Salem/ Hope Creek Environmental Audit – Post-Audit Information

Question #: ECO-7 **Category:** Ecology

Statement of Question: Please provide the following documents that were made available during the Salem and HCGS License Renewal Environmental Audit in response to Pre-Audit Question # ECO-7.

Figure IV-4. Effect of excluding data from 1995-1997 on Base Case scenario loss estimates (expressed in terms of pounds lost to the fishery) for the finfish RIS. Values presented in this graph are from PSEG (1996).

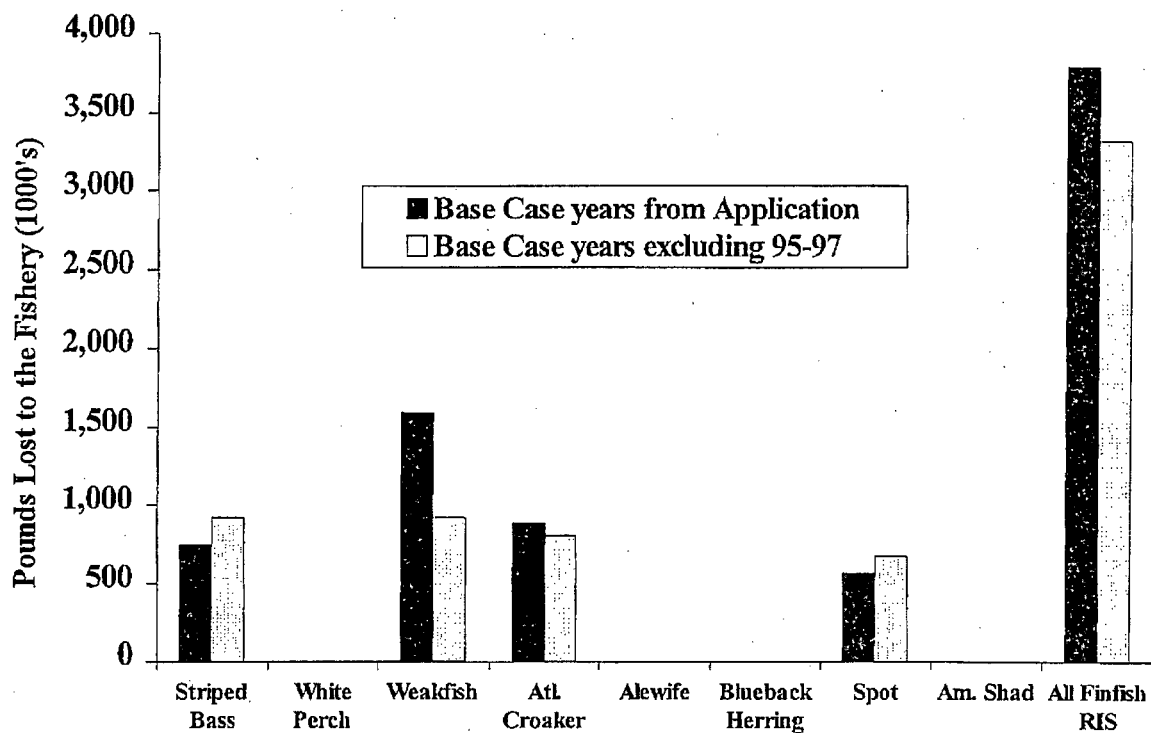
ESSA does not present any scientifically credible evidence to support its claim that data from 1995-1997 somehow compromised the validity of the Base Case scenario loss estimates. Furthermore, whether data from those years are included or excluded from the analyses has little effect on the Base Case scenario loss estimates (see PSEG 1999b and Figure IV-4). The estimates of pounds lost to the fishery (on which the Cost-Benefit analyses of technology alternatives were based) for striped bass and spot would be slightly higher if data from 1995-1997 were excluded. The estimate of pounds lost to the fishery would be slightly lower for Atlantic croaker, and would be substantially lower for weakfish, if the data from 1995-1997 were excluded. Estimates of pounds lost to the fishery for all other finfish RIS were negligibly small in comparison to the pounds lost estimates for these four species. The estimate of total pounds lost to the fishery (from all finfish RIS) would be slightly lower if data from 1995-1997 were excluded from the calculation of losses for the Base Case scenario. Similarly, excluding data from 1995-1997 from base case CMR estimates would have little effect on the estimates (see Figure IV-5). For spot and American shad, the base case CMR would increase slightly; for bay anchovy and weakfish, the base case CMR's would decrease. Data to estimate CMRs for white perch, blueback herring and alewife were only available from 1996; therefore, this type of comparison cannot be made for those species. As is the case for the base case loss estimates, the data from 1995-1997 did not have a major effect on the base case CMR estimates. The most noticeable effects are that excluding data from 1995-1997 tends to reduce base case loss and CMR estimates.

Figure IV-15. Eddy-like motion south of the Station during the change from flood to ebb tide (WHG 1995b).

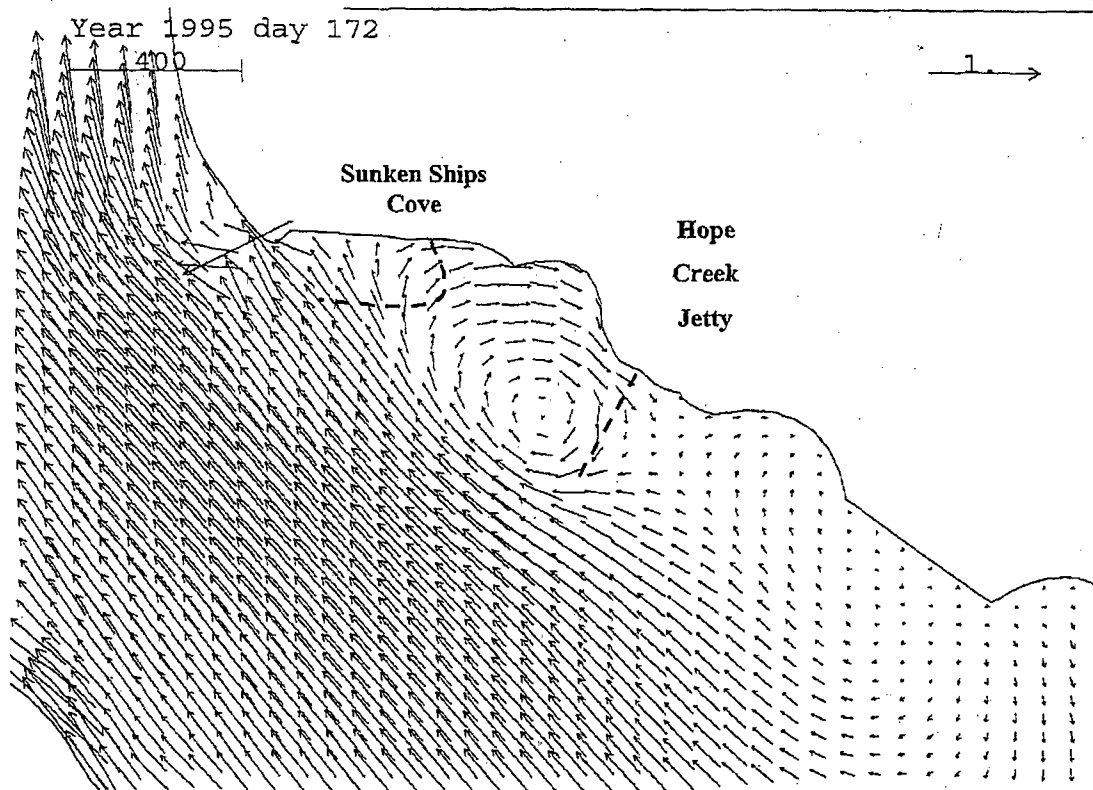
Another short-lived eddy-type motion develops during the change from flood tide to ebb tide, as the estuary begins ebbing on the tidal flats while lagging flood currents exist in the main shipping channel (Figure IV-15). This also is a short-term shear-induced motion, and the flow is directed south of the Station as the ebb tidal currents prevail (Figure IV-12).

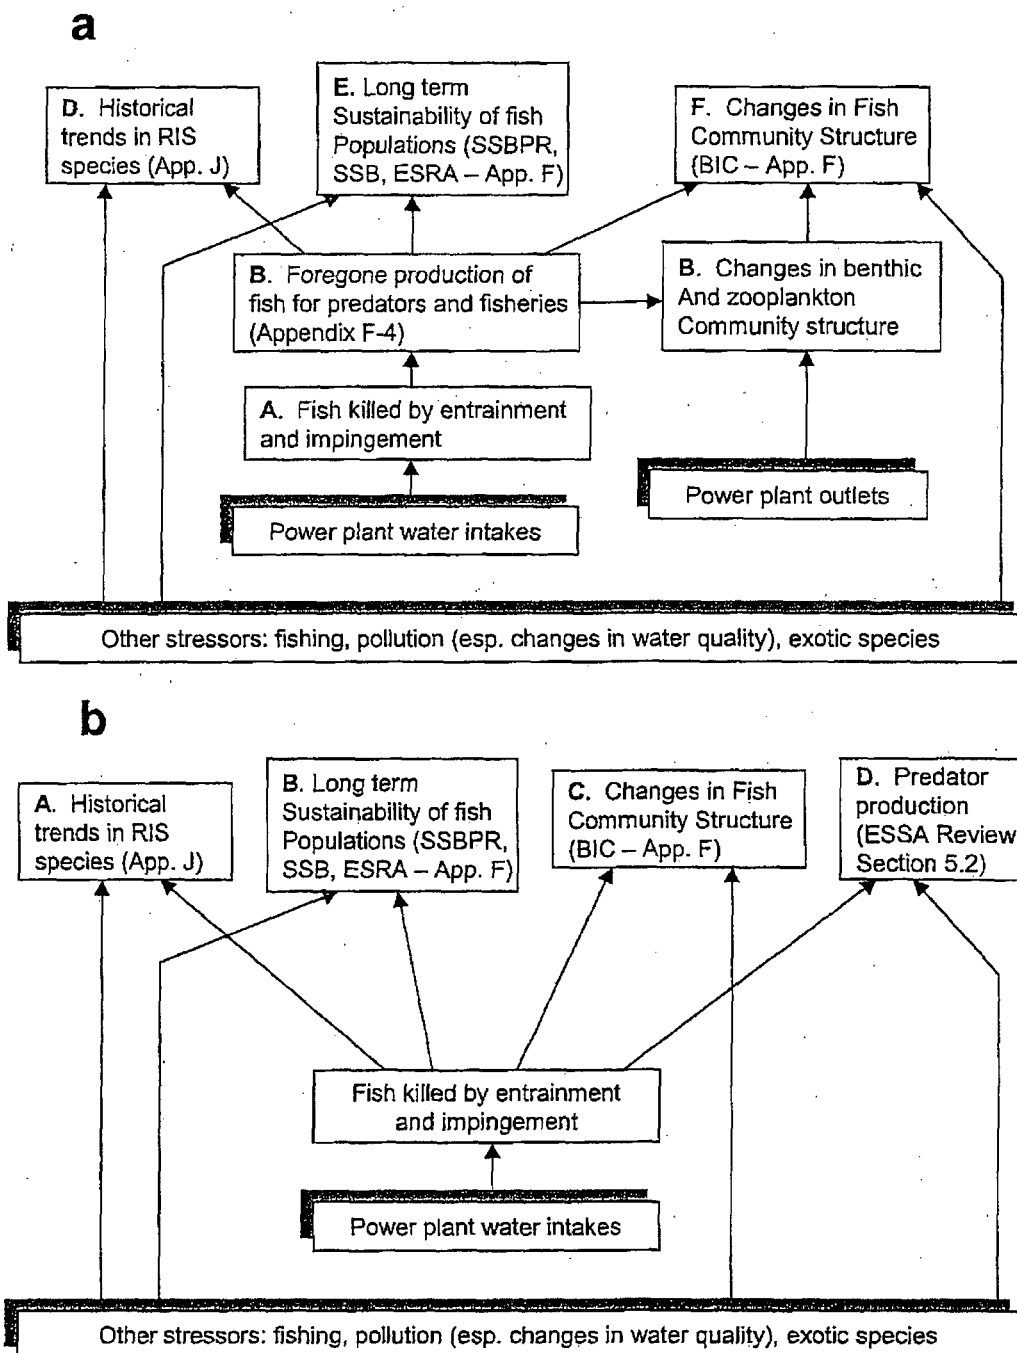
ESSA claims that the ERA Guidelines support its arguments that PSEG's AEI indicators are inadequate and that additional indicators are needed. To support this claim, ESSA provides a conceptual model of Station impacts (ESSA Report, page 83, Figure 5.1) and a table identifying five statements in the ERA Guidelines that ESSA argues support ESSA's position (ESSA Report, pages 84-85, Table 5.1). Both the figure and the table contain inaccuracies and misleading material.

ESSA's Figure 5.1 (reproduced in this Response as Figure VII-1) purports to show that the indicators advocated by ESSA - that is, Station losses, impacts of the Station on foregone production as defined by ESSA, and impacts on benthic invertebrate communities - are more directly related to Station effects than are PSEG's indicators. According to ESSA, its proposed indicators are not confounded by other stressors and therefore more accurately reflect Station impacts.

ESSA's Figure 5.1 mischaracterizes PSEG's assessment approach and incorrectly depicts the impacts of entrainment and impingement on aquatic populations and communities. First, it characterizes PSEG's three benchmarks of AEI as "indicators." As noted above, each of the three benchmarks was addressed using multiple indicators to account for the natural variability and confounding factors discussed in ESSA's review. Second, ESSA's figure includes impacts of the Station discharge on the benthic invertebrate community. Discharge impacts are not a component of a Section 316(b) assessment; therefore, this impact pathway should not be included in the conceptual model. Third, ESSA's figure identifies "fish killed by entrainment and impingement," i.e., station losses, as an assessment endpoint analogous to PSEG's benchmarks. However, numbers of organisms killed do not satisfy EPA's definition of an assessment endpoint. The ERA Guidelines state clearly that:

More importantly, ESSA's conceptual model errs in identifying foregone production of fish for predators as an intermediate step in the causal pathway linking cooling system impacts to PSEG's indicators. As reproduced in Figure VII-1, ESSA's Figure 5.1 shows that entrainment and impingement mortality reduce the production available to higher trophic levels (as measured by foregone production), which in turn affects population trends, stock jeopardy, and fish community composition. In fact, however, production available to predators is no more directly linked to Station mortality than are the population and community level AEI benchmarks developed by PSEG.

Figure VII-2. Components of ESSA's "Biomass Loss to the Ecosystem" indicator.
(Figure 5.2 of the ESSA Report)

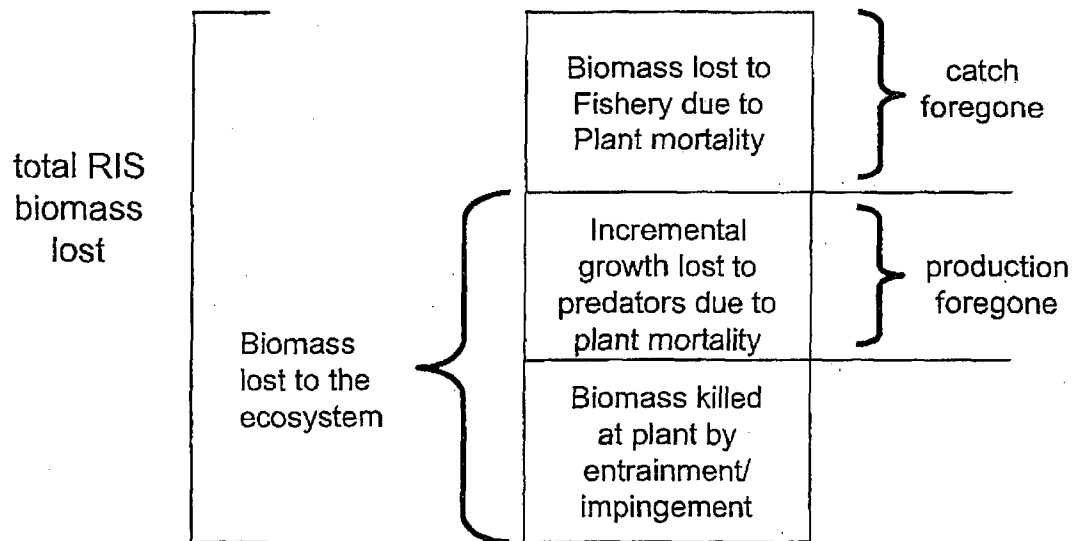
Changes in relative abundance indices over time are confounded with changes in other factors (i.e., changes in water quality, harvest rates) that may mask the effects of the station. This makes it impossible to draw conclusions about the impact of Salem on the RIS finfish and blue crab populations using the trend analyses. (ESSA Report, page 76.)

Figure VII-2 provides a conceptual model that portrays more accurately than ESSA's Figure 5.1 the causal pathways that link Station mortality to population, community, and ecosystem-level benchmarks. Station mortality directly affects populations and communities through the loss of individual members of those populations and communities. The question addressed in PSEG's Application is whether the magnitude of those losses is sufficient to adversely affect those populations and communities. Station mortality could, at least in principle, also affect predator production by reducing the availability of prey. The foregone production indicator advocated by ESSA is intended to measure this potential reduction. However, rather than being an intermediate step in the causal pathway linking Station mortality to population and community effects, production available to predators is, in reality, another independent benchmark of impact, subject to the same confounding influences (such as environmental conditions, management policies, etc.) that ESSA claims confound PSEG's indicators. The various flaws in this proposed benchmark that compromise its usefulness as a benchmark for AEI are detailed at length below in Section VII.B.2.

This lost biomass, which ESSA interprets as being the reduction in future food eaten by predators, is according to ESSA composed of "... the total reduction in future growth, measured in units of biomass, attributable to organisms killed as a result of entrainment and impingement at the Station" (referred to by ESSA as production foregone) and the biomass directly lost due to station mortality (i.e., the biomass of the entrained and impinged organisms at death). (ESSA Report, pages 86-87). The total biomass lost due to the Station, according to Figure 5-2 of the ESSA Report, is equal to the sum of the production foregone and the catch foregone by fishermen due to Station mortality (see Figure VII-2, reproduced from ESSA Report, page 87, Figure 5-2).

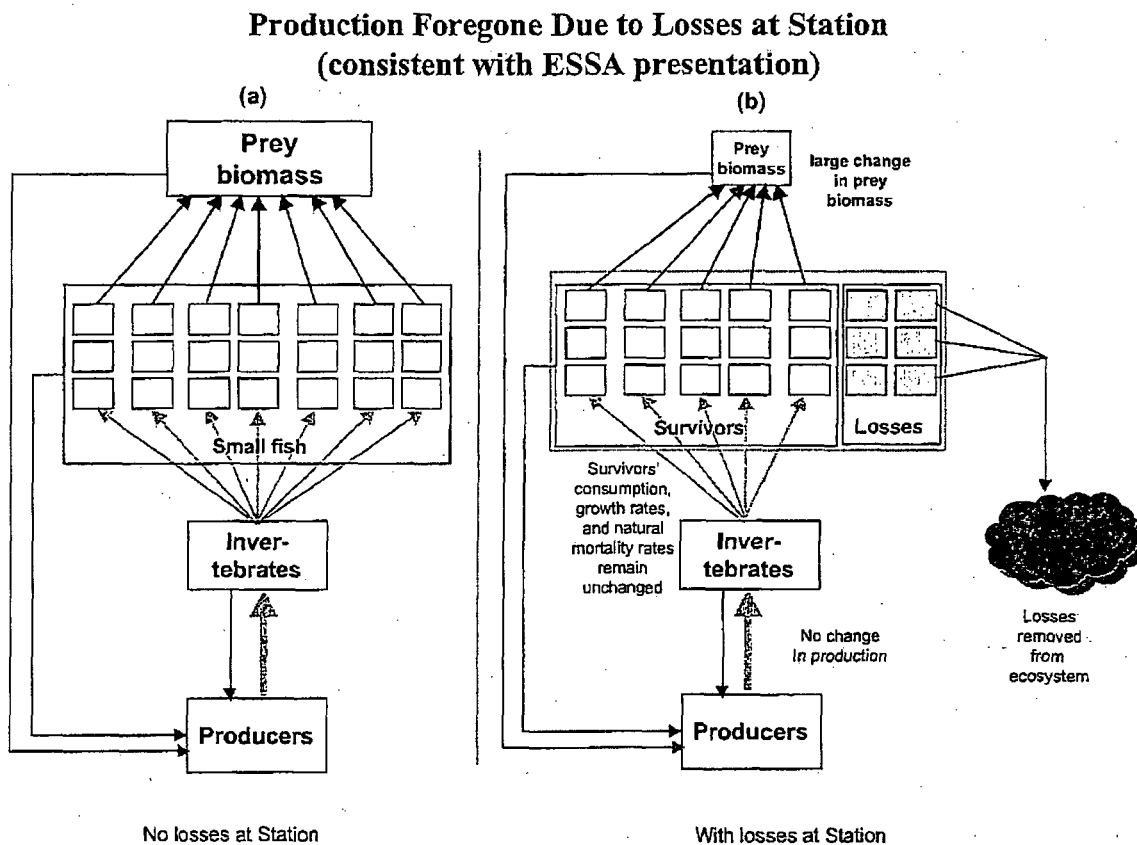
ESSA's proposed BLE methodology is based on an overly simplistic conceptual model of the Delaware ecosystem that neglects many important biomass and energy transfer processes. As shown in Figures VII-4a and VII-4b, fish production within the Estuary is ultimately determined by primary production. Carbon is transformed into a biologically available form by green plants (including phytoplankton and marsh vegetation) or derived from the decay of organic matter (dead plants and other organic material derived from aquatic, marsh or terrestrial sources). Invertebrates such as opossum shrimp and scud consume plants and decaying organic material, and are consumed, in turn, by small fish, including forage species such as bay anchovy and early life stages of other species. These small fish constitute the prey biomass available for consumption by predators such as striped bass and weakfish.

Figure VII-4b depicts the biomass production process in the Estuary that is implied by ESSA's BLE approach. ESSA's approach assumes that entrainment and impingement remove fish that otherwise could have been eaten by predators. The entrained and impinged fish and all of their future growth, had they survived, are removed completely from the ecosystem. Primary production remains the same and the growth and survival rates of the surviving fish are unchanged, but the amount of prey biomass available to predators is reduced substantially.

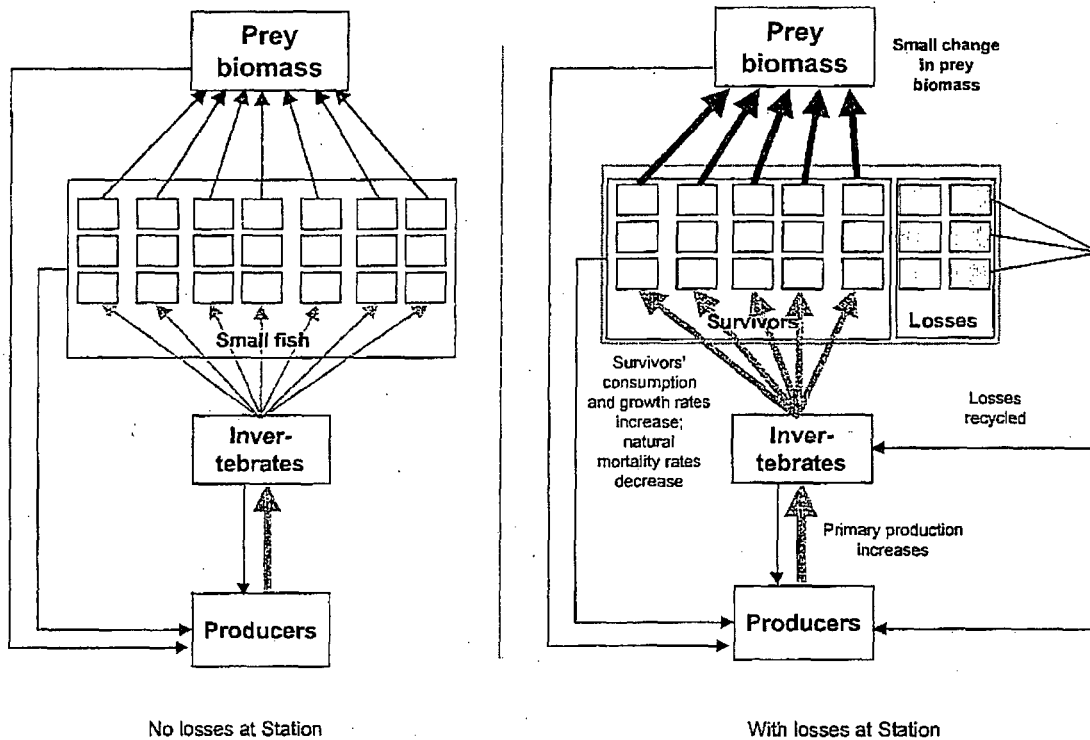
A more realistic depiction of the Estuary's biomass production process is shown in Figure VII-5a. This figure more realistically shows that the prey organisms that would have been consumed by the entrained or impinged fish are available for consumption by the survivors. Because of reduced competition and increased prey availability, the survivors grow more rapidly and suffer lower rates of natural mortality. Ultimately, a large fraction of the prey biomass lost due to the deaths of entrained and impinged fish may be recovered due to a compensatory increase in the prey biomass provided by the survivors.

While the degree to which the compensatory processes depicted in Figure VII-5b offset the direct effects of losses at the Station is unknown, the processes themselves are well documented in Appendix I of the Application. It is possible that the only biomass actually lost to the ecosystem is the biomass of the entrained and impinged organisms at the time of death ("biomass killed" in ESSA's terminology). Even this loss may simply be a transfer of biomass from the pelagic food web to the benthic food web, with no net loss in ecosystem productivity.

Figure VII-17. Species richness (upper panel) and species density (lower panel) in the nearfield region, 1970 through 1999. No response to the 1996-1997 shutdown is apparent. Only the summer season is shown; results for spring and fall are similar.

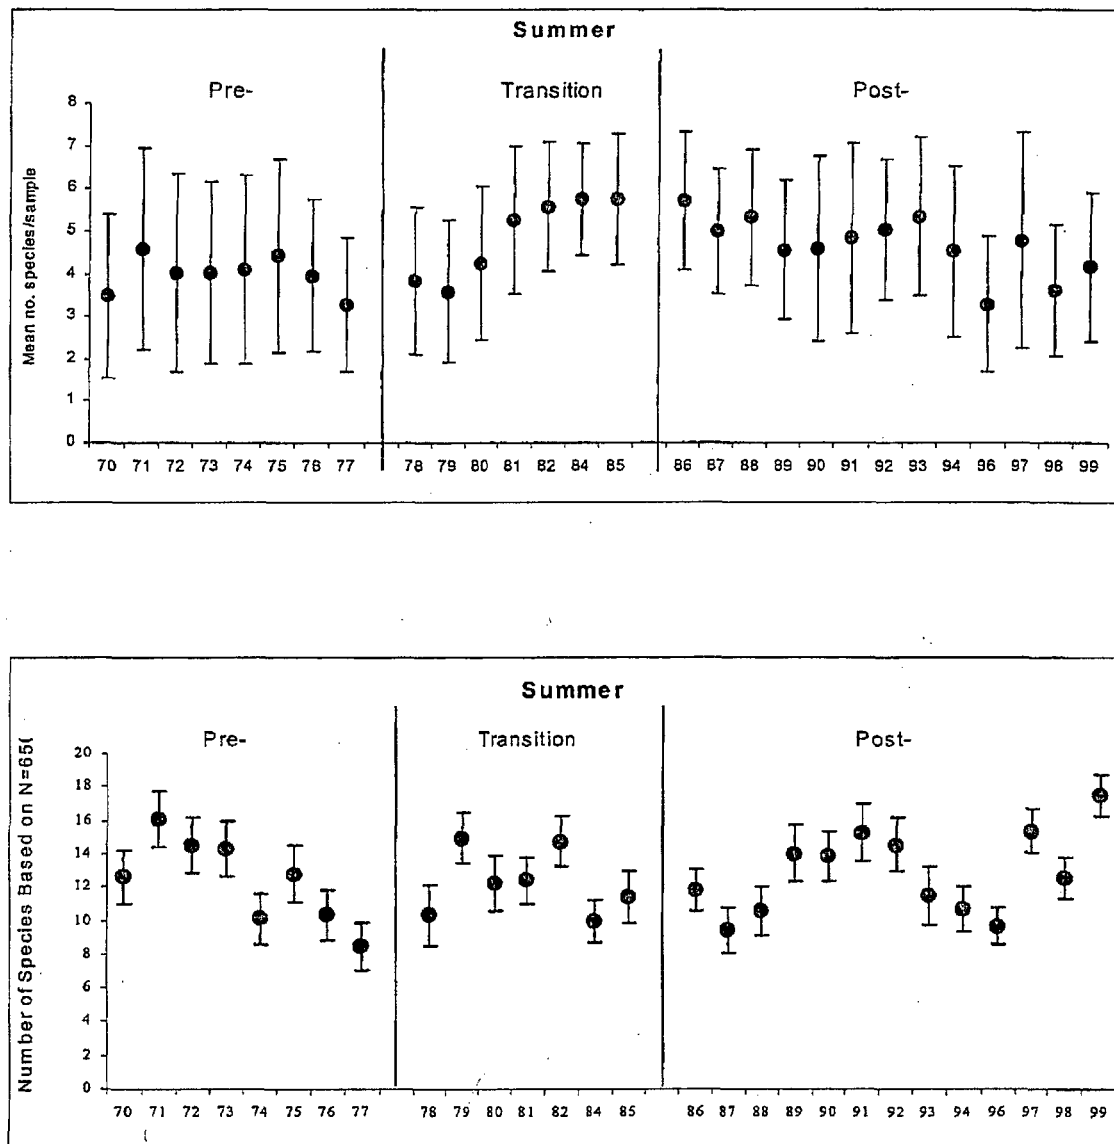
ESSA notes that dates for which nearfield bottom trawl data are available are listed in the text of the Application as being 1970 through 1998, excluding 1983, 1987, and 1995, but that the Application (see Application Appendix F, Figure 2) also excluded the years 1984 through 1986 from the data set and that the nearfield bottom trawl data in Application Appendix L do not include any pre-1980 data. (ESSA Report, page 106.)

The inconsistency between the years noted in the text of the Application (Application Appendix F, Section VII.A.1.b) and the years identified in Figure 2 and in Appendix L are due to differences between the BIC presence/absence analysis and the trends analysis (1999 Application Appendix F, Section VIIB). Because the trends analysis relied on quantitative estimates of relative abundance, the trends analysis required more stringent data selection criteria than were necessary for the presence/absence analysis. During the years 1984 through 1987, the full nearfield bottom trawl program was not conducted, but limited sampling was conducted in the immediate vicinity of the Station as part of the W-factor sampling program (see Application Appendix F, Attachment 1, Section III.A.2.b). Because sampling did not cover the full region, these data were not used in the trends analysis. They were, however, used in the presence/absence analysis. The text of Section VII.A.1.b of the Application should have stated that data were available for all years between 1970 and 1998, excluding 1983-1987 and 1995. W-factor samples were collected in 1987, and were used in the presence/absence analysis. Appendix L, Tab 15 provides the annual abundance indices used in the trends analysis (Application Appendix L, Tab 15). The starting date for the PSEG near-field time series was 1979, not 1980 as stated in ESSA's comment. As discussed in Appendix J of the Application, the trends analysis excluded PSEG bottom trawl data collected prior to 1979 because of a change in the sampling protocol that affected the relative abundance estimates (although not the species counts).
